GULF STATES UTILITIES COMPANY

November 5, 1984
RBG- 19,354
File Nos. G9.5, G9.19.2

River Bend Station - Unit 1
Docket No. 50-458

RESPONSES TO REQUESTS FOR INFORMATION
IN SECTIONS 2.2, 2.3, AND 2.4 OF ENCLOSURE 3
TO NRC DECEMBER 22, 1980 LETTER

FIGURE 8
 RIVER BEND STATION
 HEAVY LOAD DROP IMPACT REGIONS
 FUEL BUILDING, EL 148'-0"

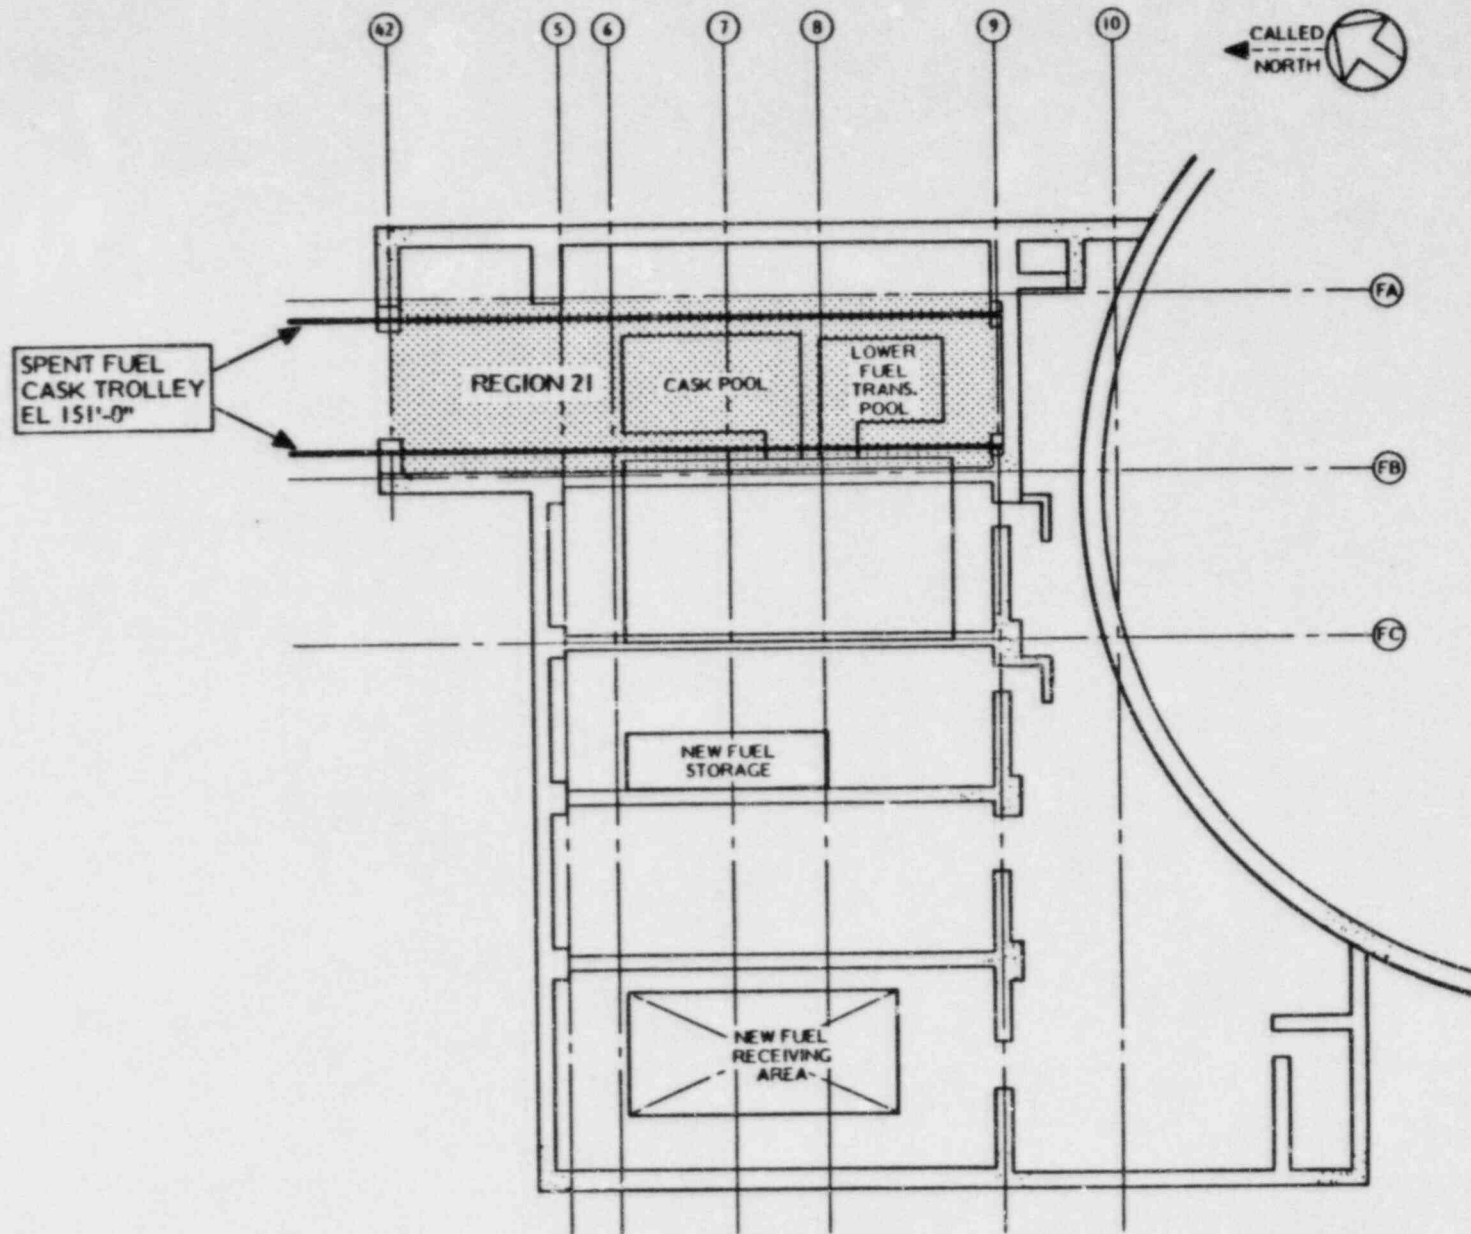
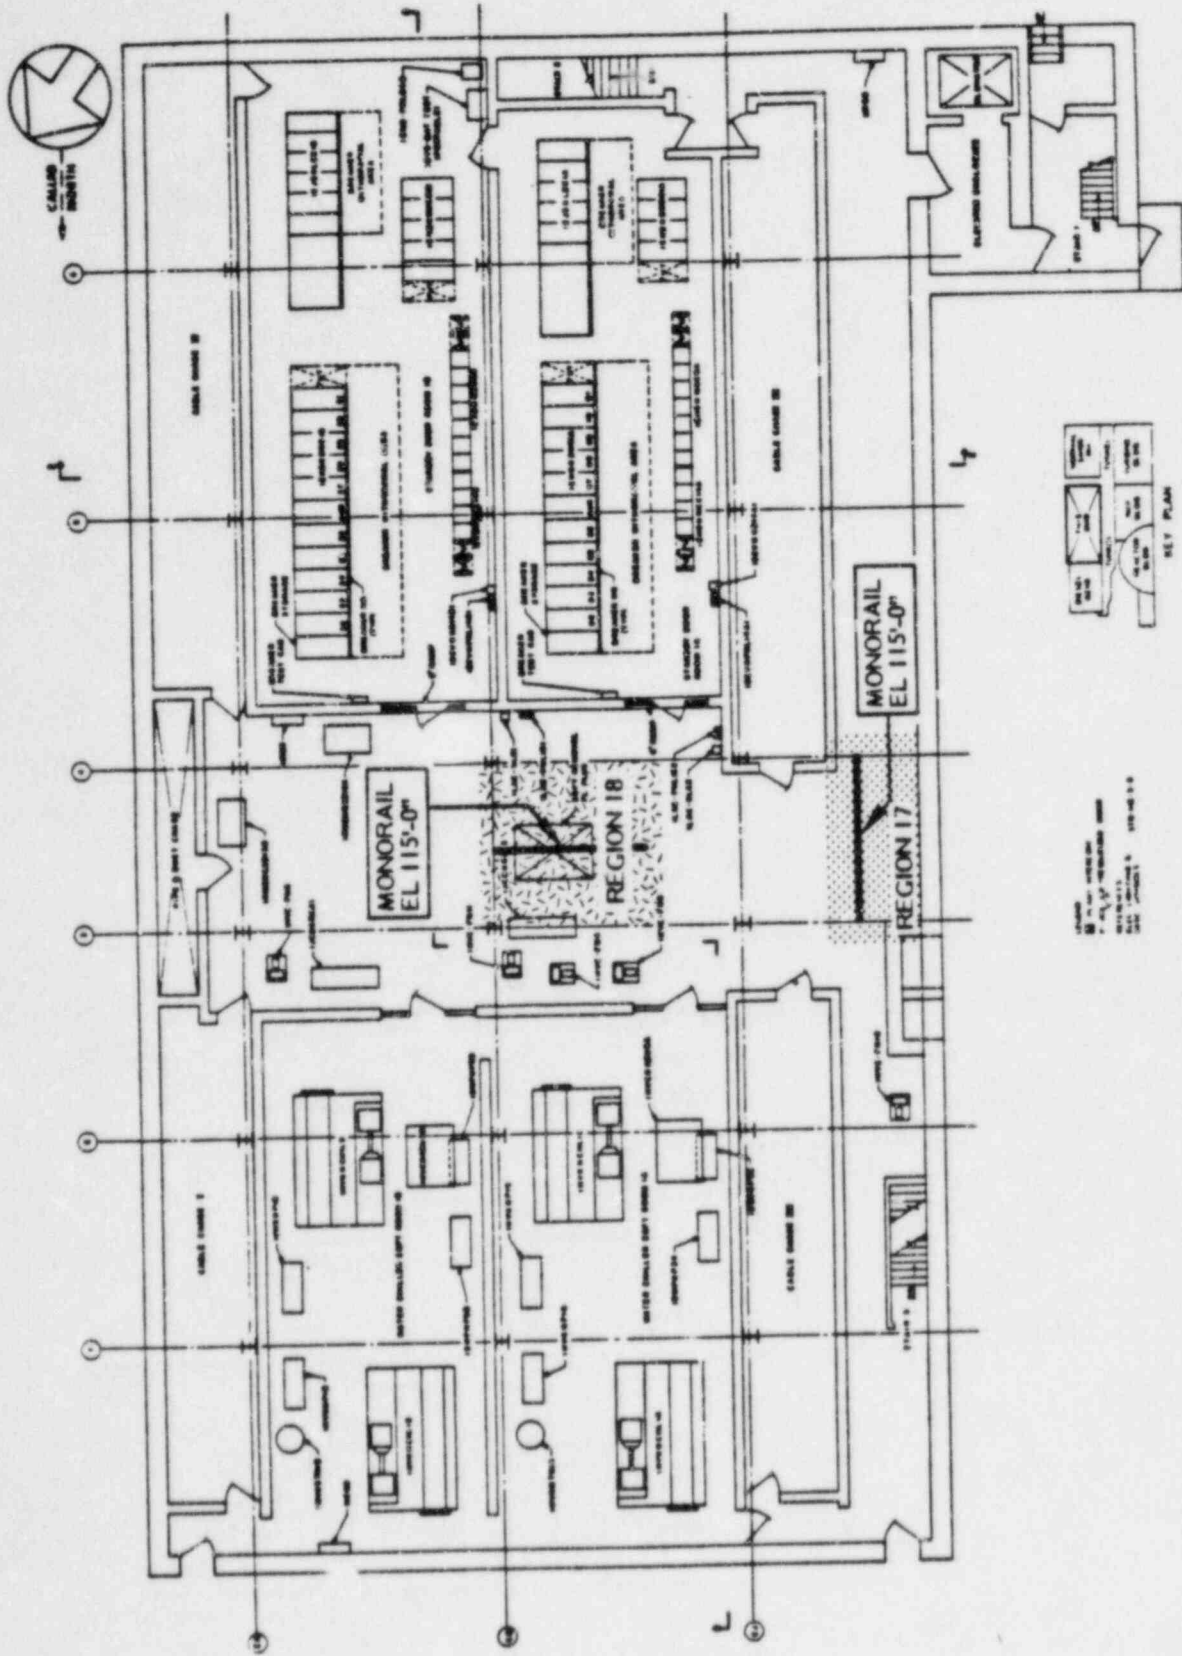
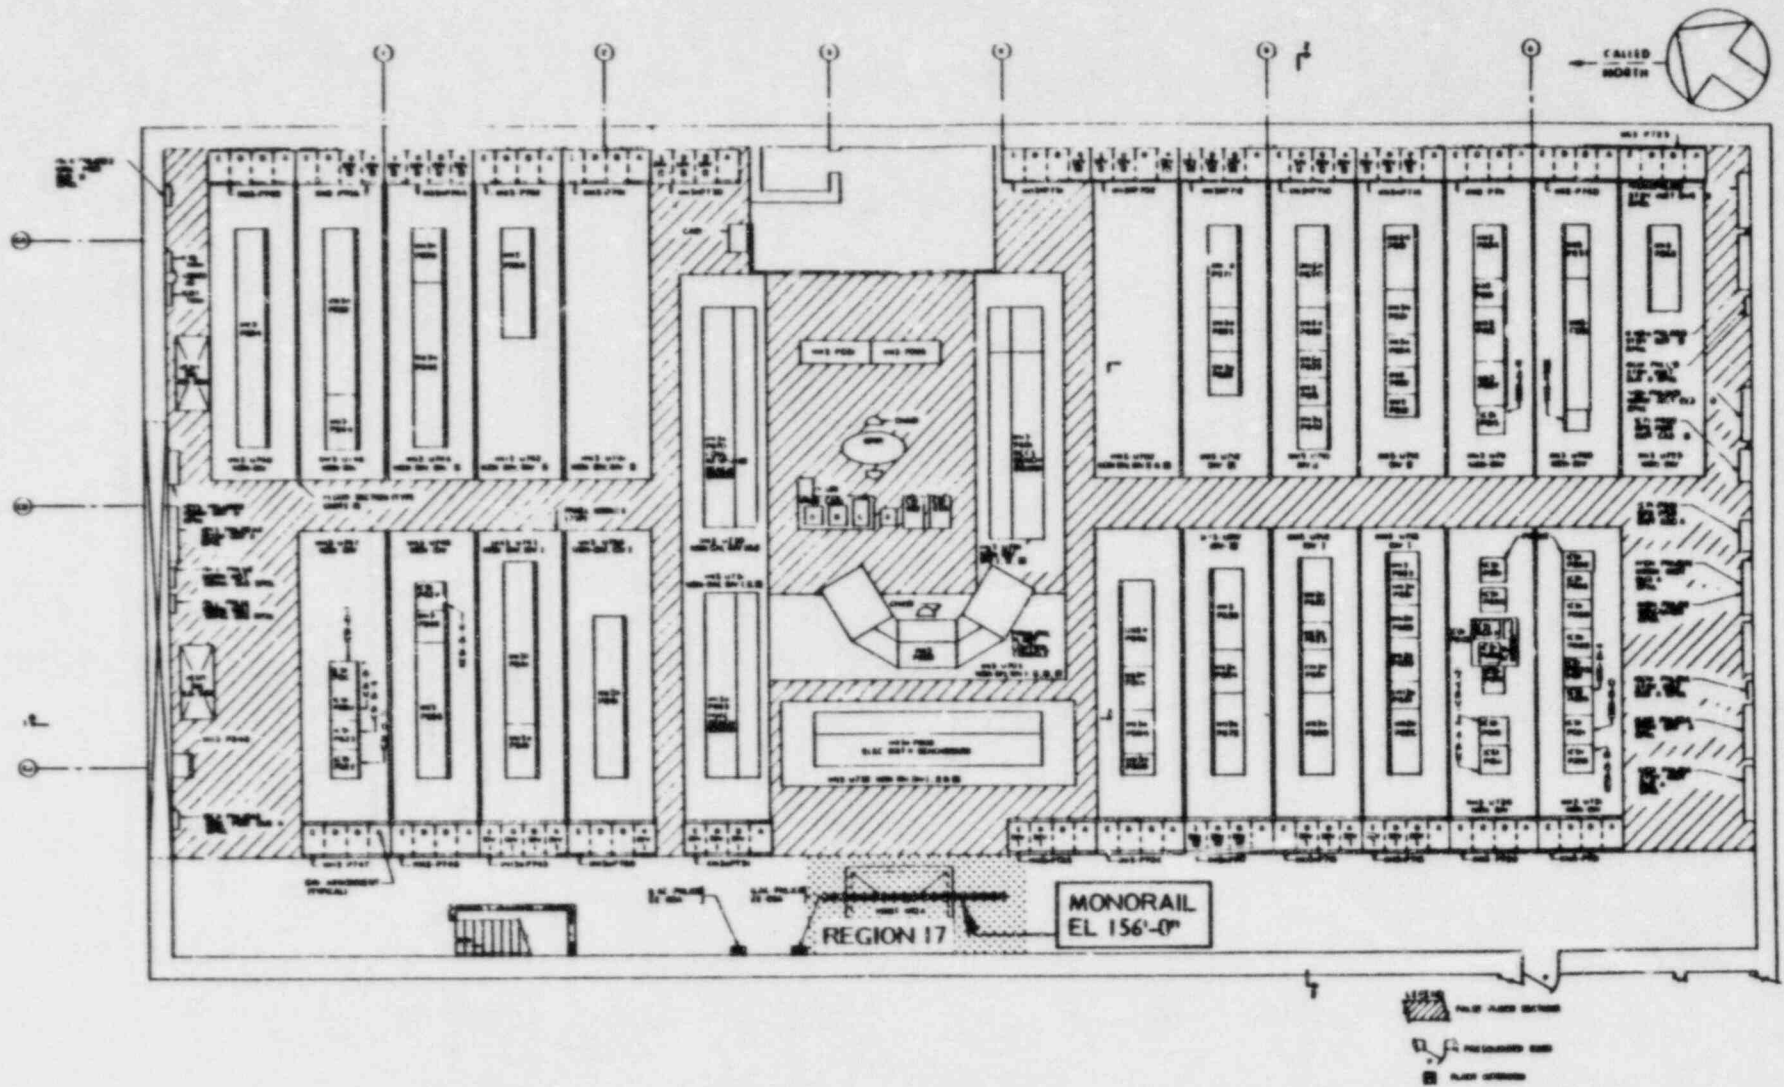
ITEM 2.4.2 For any cranes identified in 2.1-1 not designated as single-failure-proof in 2.4-1, a comprehensive hazard evaluation should be provided which includes the following information:

- a. The presentation in a matrix format of all heavy loads and potential impact areas where damage might occur to safety-related equipment. Heavy loads identification should include designation and weight or cross-reference to information provided in 2.1-3-c. Impact areas should be identified by construction zones and elevations or by some other method such that the impact area can be located on the plant general arrangement drawings. Figure 1 provides a typical matrix.

RESPONSE: Table I identifies the potential impact regions and the associated load handling systems. The loads corresponding to these handling systems were previously identified in response to item 2.1-3c. Figures I through II further describe the potential impact regions. For the handling systems identified in Table I (also listed in 2.4.1 above) a combination of systems and structural evaluations was utilized to determine if Criteria IV of NUREG-0612 is met for all postulated load drop scenarios. To assist these evaluations, a set of safety functions were identified corresponding to these criteria. The goal of these evaluations then became to demonstrate that the applicable safety functions could be accomplished for all load drop scenarios.
